ADCTelecommunications				1		9399		4/18/98		SEB							
								REV		ECO		DATE		APV							
ALL DIMENSIONS IN INCHES UNLESS OTHERWISE NOTED.				APV		THIS PRINT IS THE PROPERTY OF ADC, IT SHALL NOT BE COPIED WITHOUT PERMISSION.				TITLE A/D, 2 WAY COMBINER/SPLITTER 2.5-2.7 GHz											
TOLERANCES UNLESS OTHERWISE NOTED.				DATE		MATERIAL															
.XX ±.02 FRAC ±1/64				ECO		-----				DWN		SAK		1/27/98		DWG. NO.		REV			
.XX ±.005 ANG ±0° 30'				REV		FINISH				CHK		SEB		2/16/98		2111-5008		A0			
BREAK ALL SHARP EDGES DO NOT SCALE DRAWING						-----				REL		SEB		2/16/98		C		SCALE 1=1		SHEET 1 OF 1

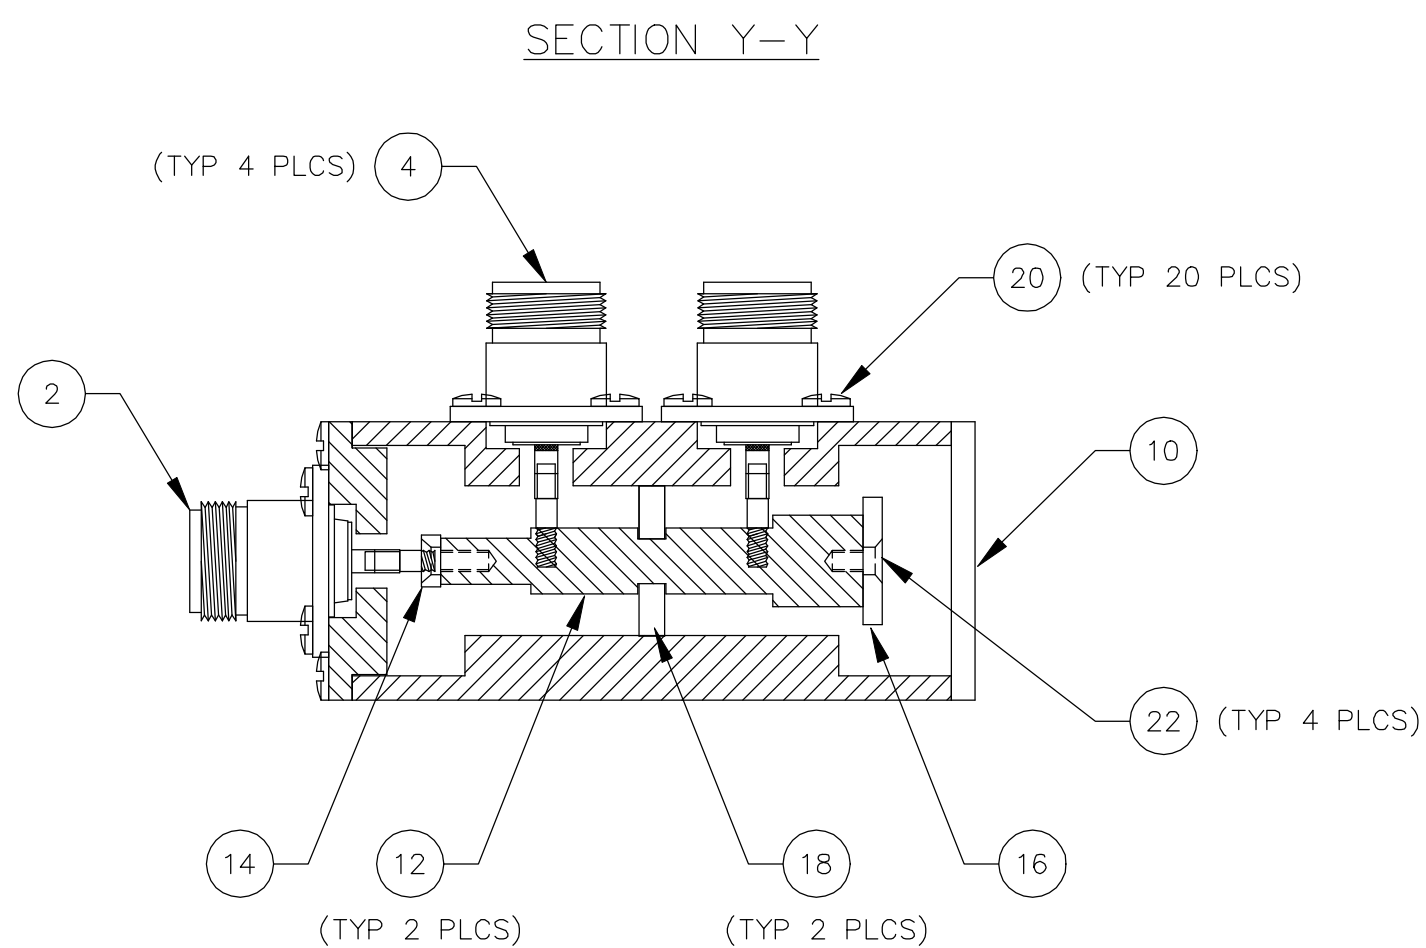
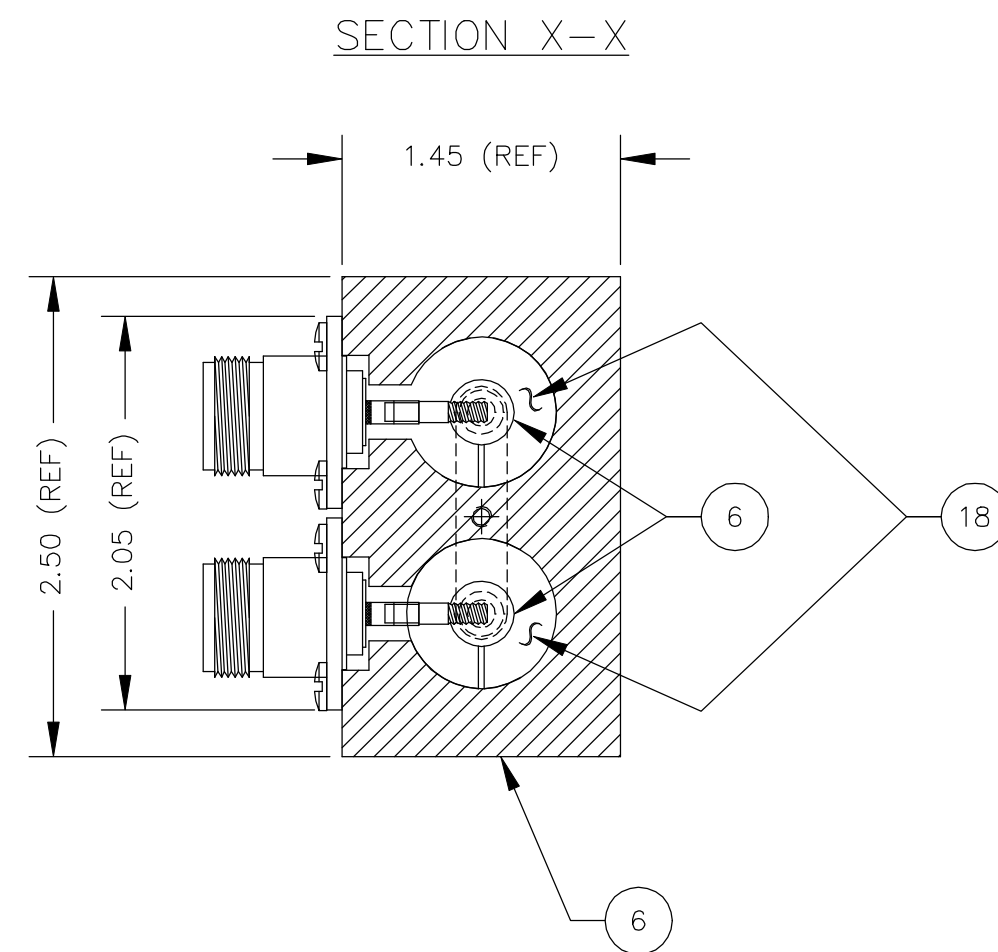
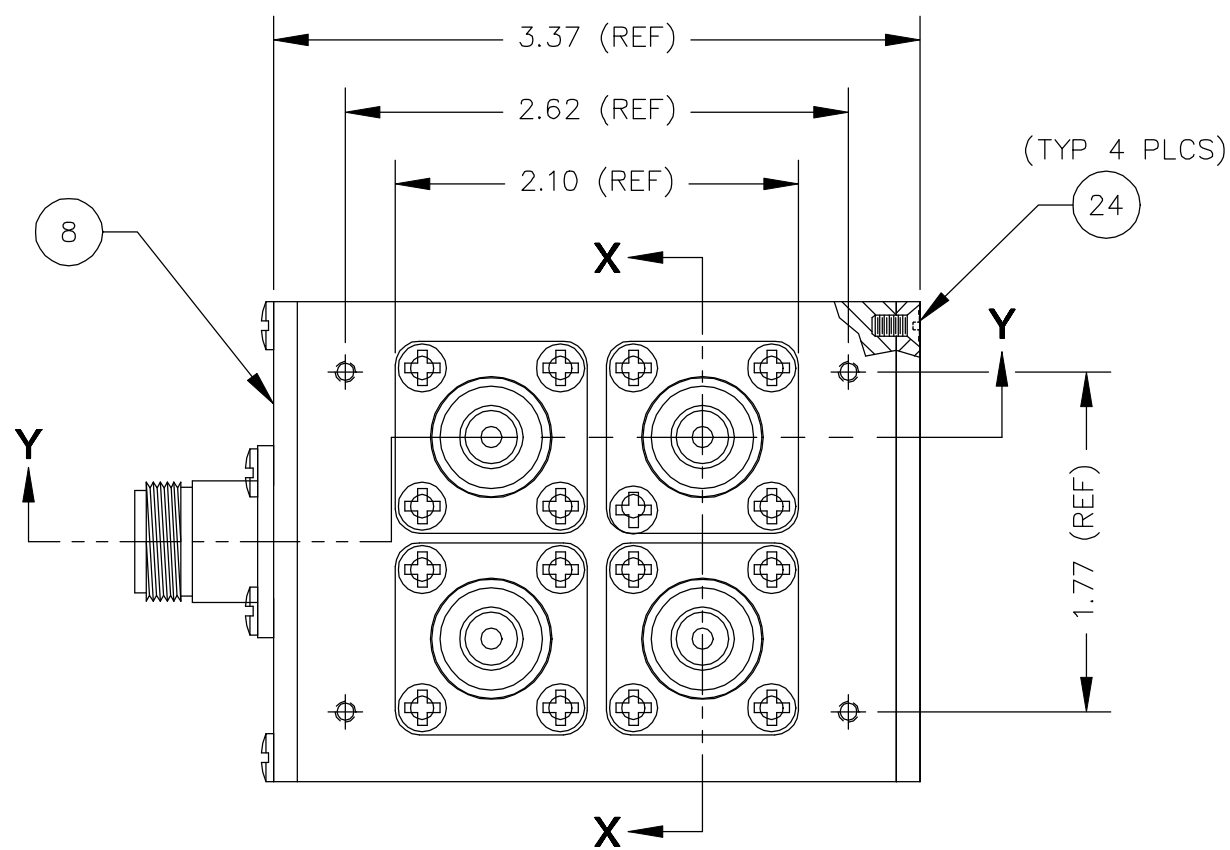
REMOVED CUTOUT VIEW AT TOP VIEW. ADDED ITEM 24 BALLOON (F.H. SCREWS). ADDED H-REF DIMS 2.62 & 2.10. ADDED V-REF DIMS 1.77 & 2.05. (SAK)

2.50 DIM WAS 2.45. 3.37 DIM WAS 3.36. DELETED NOTE 2. (RFB)
